MONTGOMERY COUNTY HISTORIC PRESERVATION COMMISSION
STAFF REPORT

Address:	7818 Overhill Rd., Bethesda	Meeting Date:	3/27/2019
Resource:	Contributing Resource Greenwich Forest Historic District	Report Date:	3/20/2019
Applicant:	William and Allison Trunk	Public Notice:	3/13/2019
Review:	HAWP	Tax Credit:	n/a
Case Number:	35/165-19A	Staff:	Dan Bruechert
PROPOSAL: Partial Demolition and Building Addition

PROPOSED ELEVATIONS
Scale: 1/8" = 1'-0"

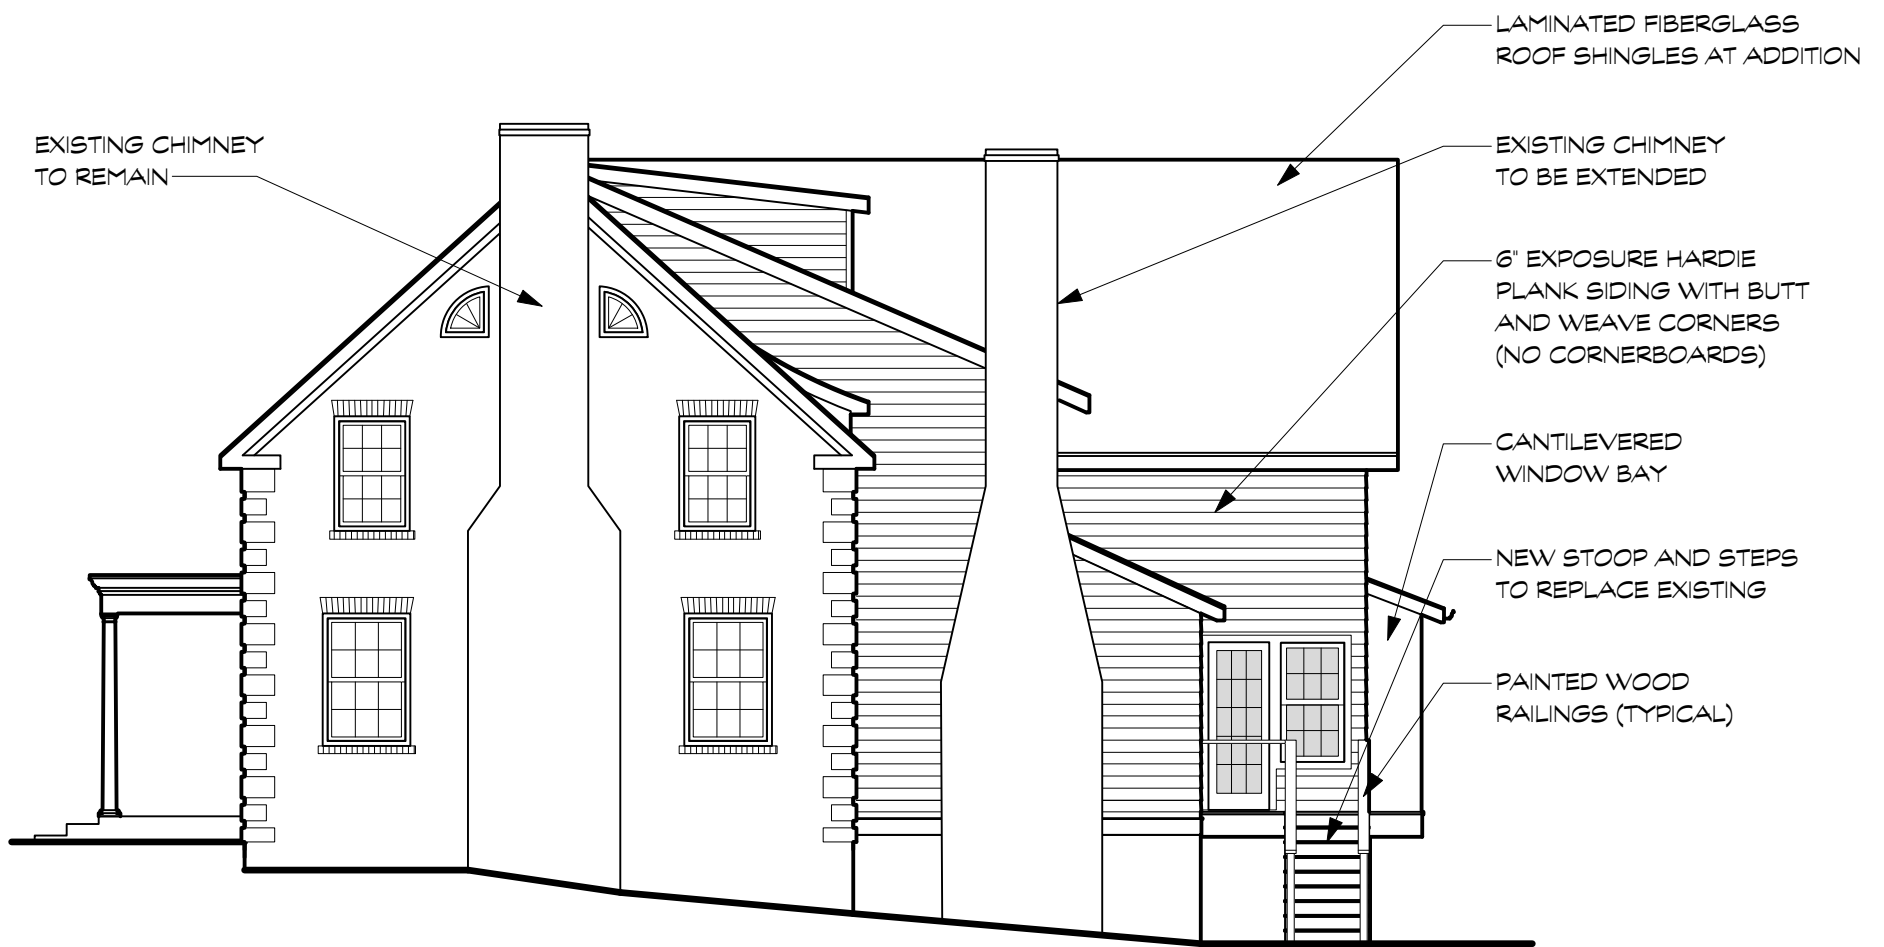
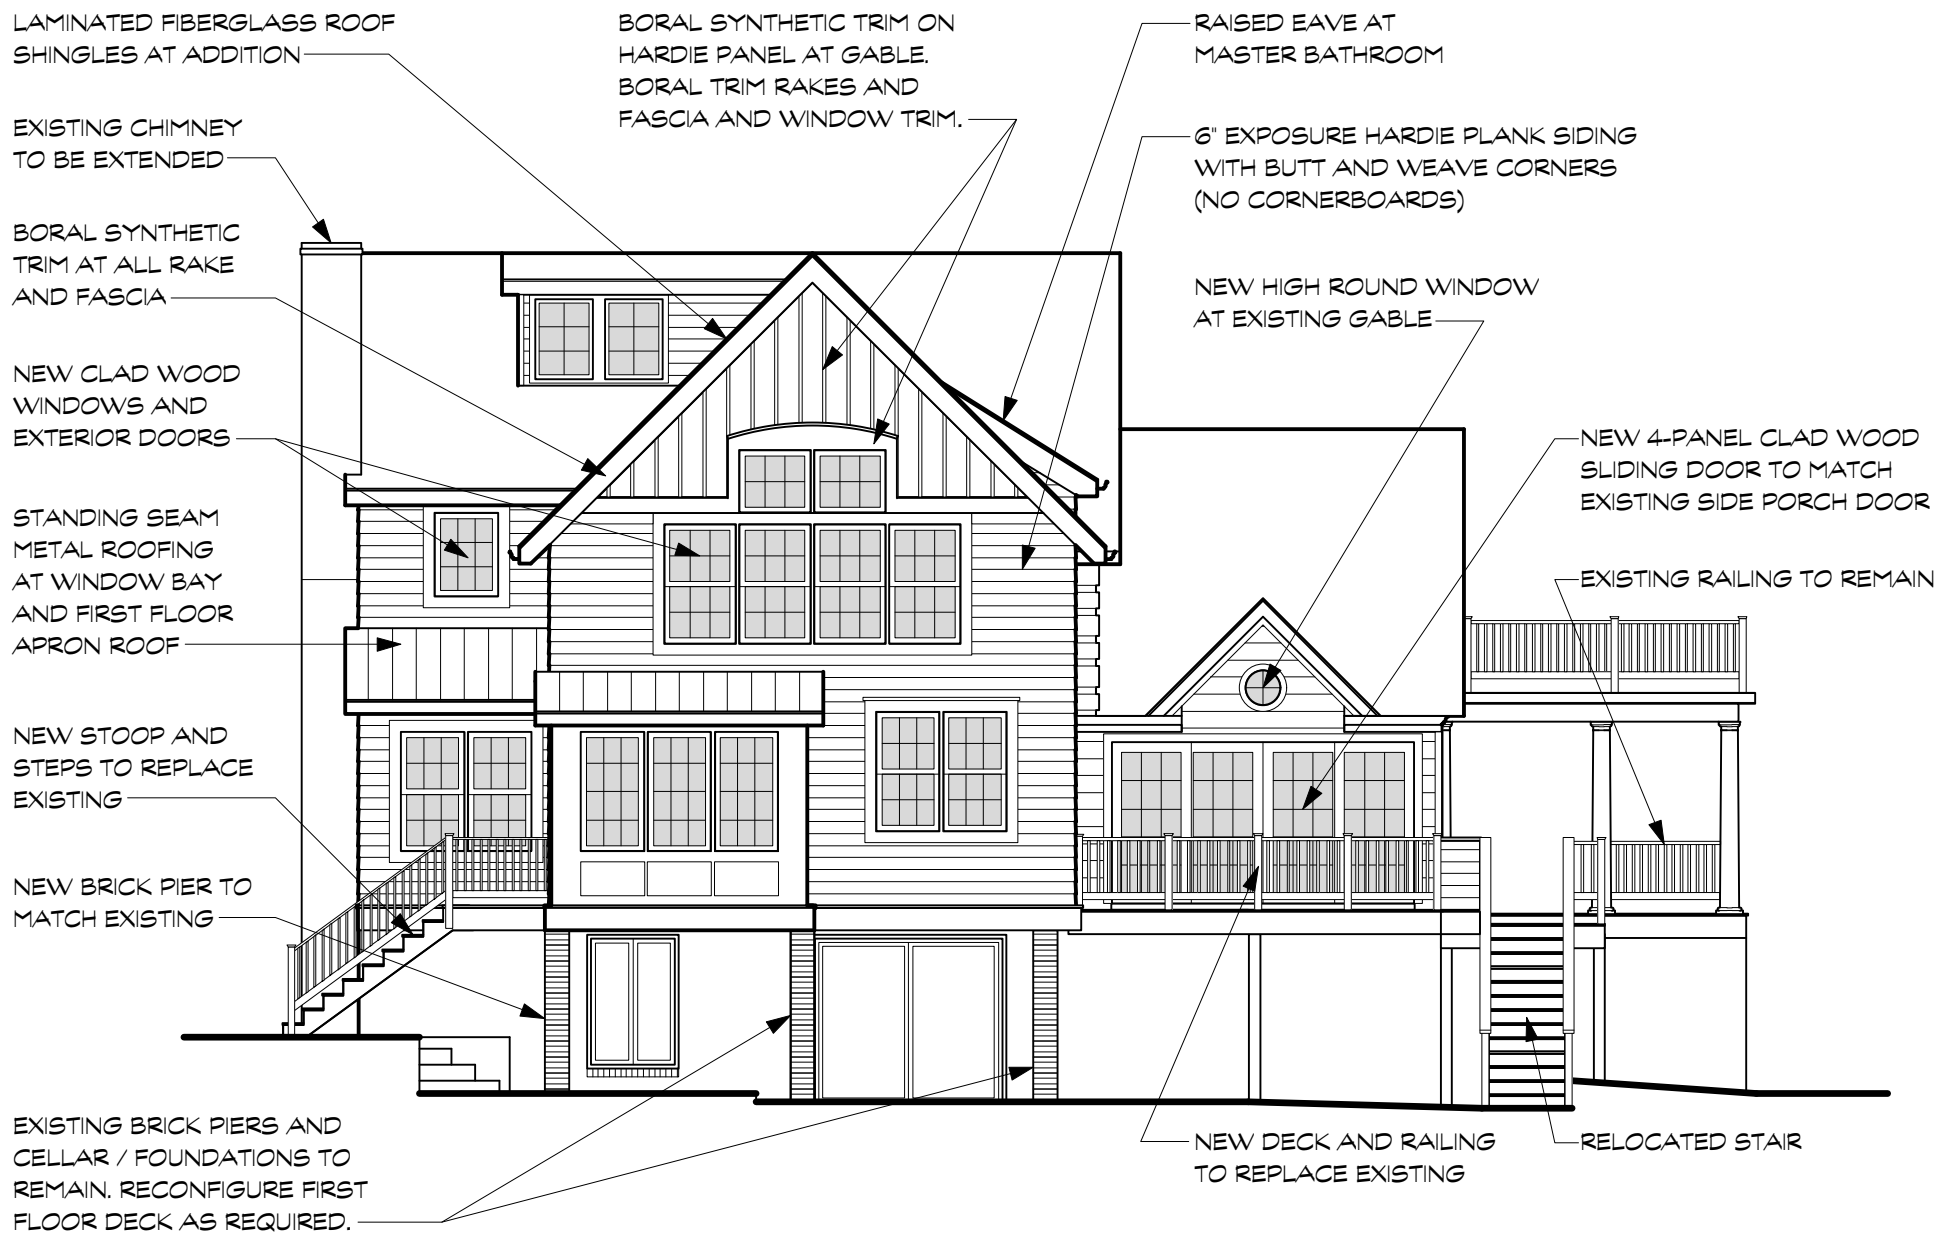
The applicant proposes to replace the top two floors of the rear addition, replace the rear deck, and rear stoop. The new addition will be constructed on the foundation of the non-historic rear addition. The new addition will have a large rear-facing gable roof with small shed-roof projections. The new addition will require the construction of a new brick pier which will match the existing two brick piers. The total house footprint will increase by 86 ft² (eighty-six square feet). The addition will be sided in fiber cement siding in a 6" (six inch) reveal. The windows will be a mix of sash and casement windows and, along with the proposed doors, will be Weather Shield Signature Series aluminum clad wood windows. The new roof will be covered in architectural shingles. As part of this construction the existing brick chimney on the north elevation (right side) of the addition will be extended above the new roof of the addition; it will extend approximately 2'6" above the new ridgeline and will have the same coping details as the existing chimney. The new deck will be constructed out of wood with wood stairs and railings.

While the new addition is being constructed on the existing foundation, the proposal will reconfigure the roofline of the rear addition, from a rear-facing shed roof to a rear-facing gable roof. The ridgeline of the rear addition will match the principal side-gable ridge. Staff finds that this design change is appropriate under the *Design Guidelines* which state, “Alterations should be designed so that the altered structure does not detract from the fabric of Greenwich Forest while affording homeowners reasonable flexibility... Permitted changes should be compatible with the structure’s existing architectural designs.” Staff finds that as this change in massing is behind the both the larger massing of the house and the side projecting gable addition. It will not detract from the district and Staff supports the change in massing. This is consistent with provision B5, which gives property owners additional flexibility under the *Guidelines* to more extensive changes to the parts of their houses that are less visible from the public right-of-way.

The design of the new addition is best described as traditional. The only design embellishment is the board and batten gable feature under the rear gable. The addition’s design is consistent with the appearance of the side-gable addition and Staff finds this to be a compatible design with the Colonial Revival features of the historic house. Staff finds this design treatment is consistent with provision D5 of the *Design Guidelines*.

4 RAILING DETAIL

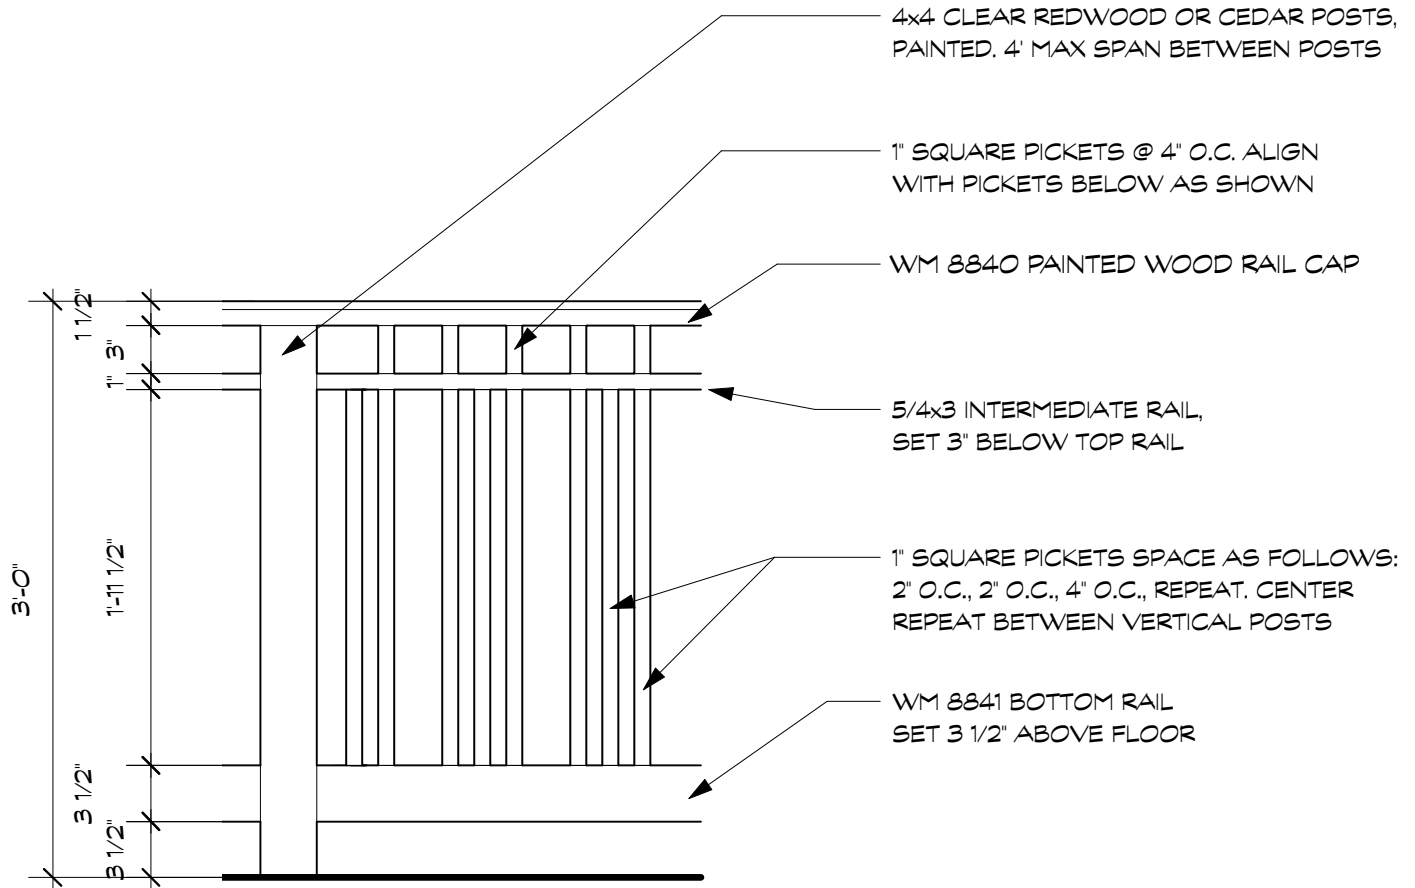
The applicant proposes to reconstruct the rear deck and to construct a new set of steps and a stoop. The deck and stoop will be constructed out of wood and will have a wood railing with the

pickets inset between the top and intermediate rail (see attached railing detail). The reconstructed deck is proposed for the same location as the existing deck but will have a new set of rear-loading steps. These new steps will not change the character of the house and will not be visible from the public right-of-way. The new stoop will be approximately 8' × 9' (eight feet by nine feet) and will have a set of side loading in the same location as the existing rear steps. These changes are on less visible elevations of the house and are entitled to lenient review. Staff supports approval of the rear deck alterations.
